CITY OF ALBUQUERQUE

RE: **Lot 4 Block 3 Unit 22 SAD 228
6324 Camino Alto NW
Grading and Drainage Plan
Engineers Stamp Date 8/4/2022 (D10D003R4)**

DRAINAGE AND TRANSPORTATION INFORMATION SHEET (REV 6/2018)

ENGINEER'S SEAL  8/4/22	6324 CAMINO ALTO	DRAWN BY: WCVJ
	GRADING AND DRAINAGE PLAN	DATE: 8-04-22
 1606 CENTRAL AVENUE SE SUITE 201 ALBUQUERQUE, NM 87106 (505) 872-0999		20220055-LAYOUT-7-27-22
		SHEET #
		JOB # 20220055

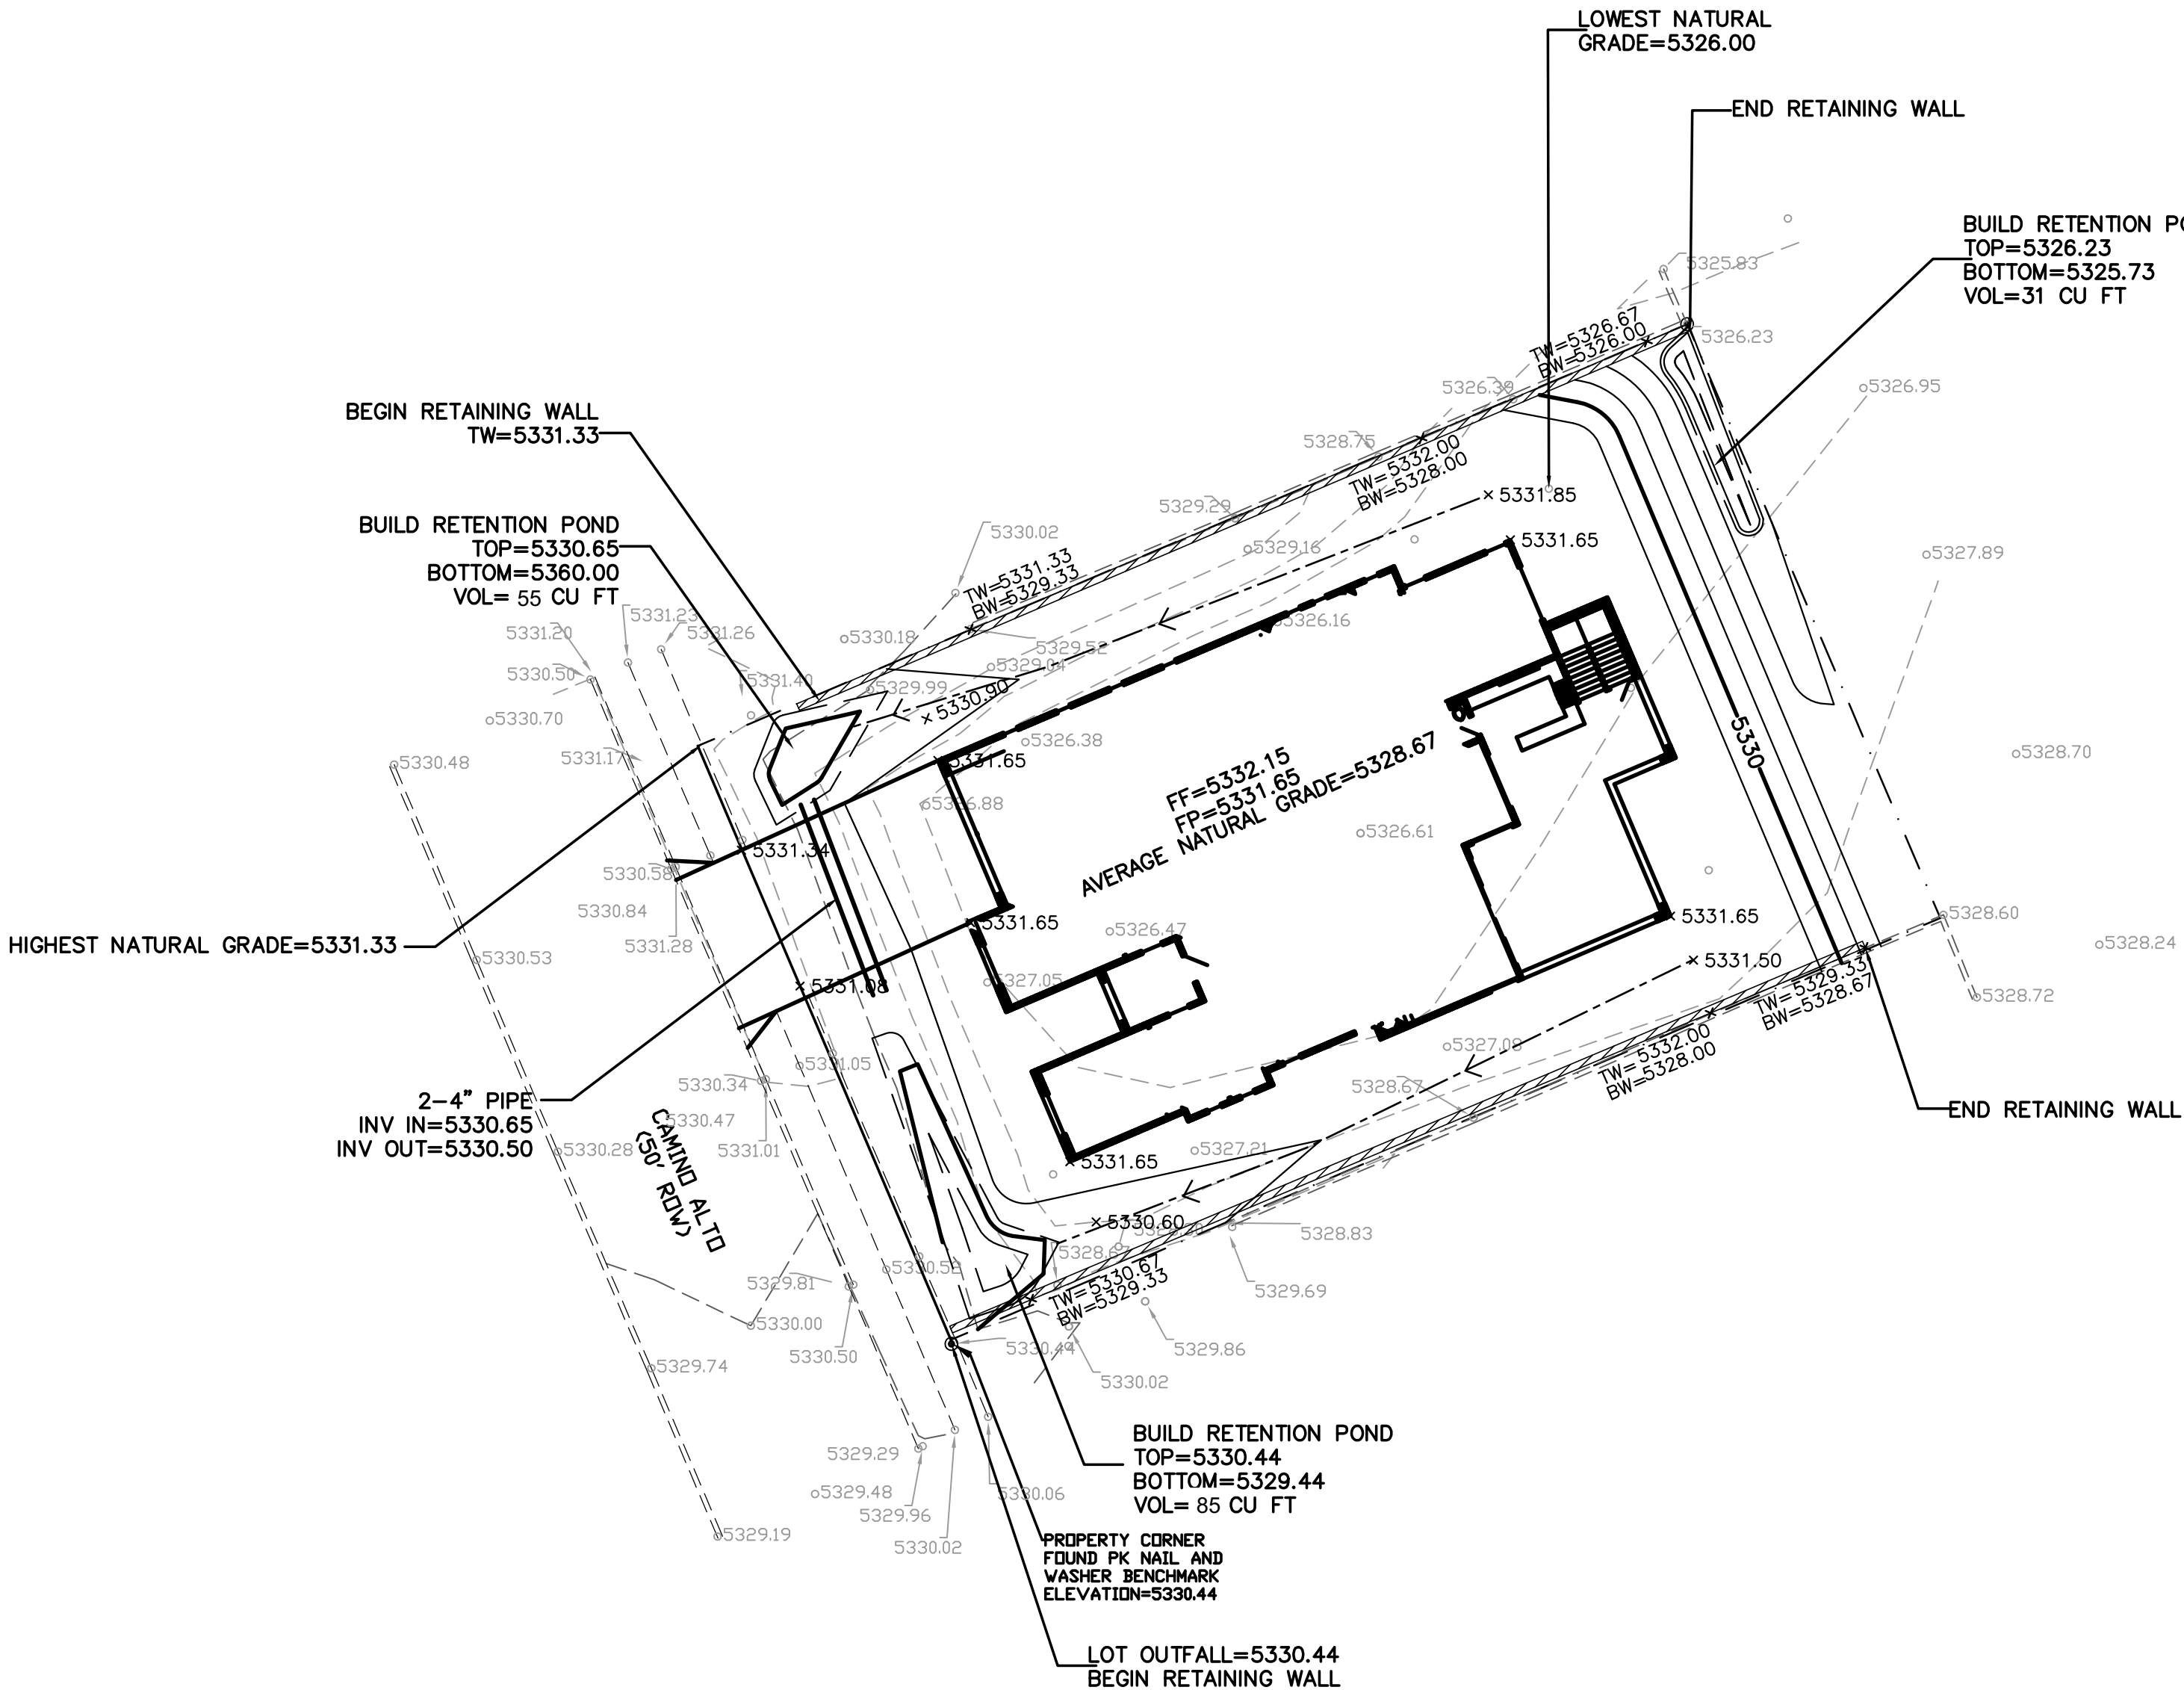
Based upon the information provided in your submittal received 8/8/2022, this plan is approved for Grading Permit.

Prior to Building permit approval a Pad Certification will be required, provided by the Engineer or a registered Land Surveyor.

Advise the owner contractor not to use dirt as a ramp to climb the curb, use lumber or crusher fines for this purpose.

Reiterate to the Owner/Contractor that a separate permit for a garden/retaining wall must be obtained with the approved G&D plan and Pad Certification. Also, if a swimming pool is to be placed the grading and drainage plan will change and will need to be resubmitted.

Prior to Certificate of Occupancy release, Engineer Certification per the DPM checklist is required.
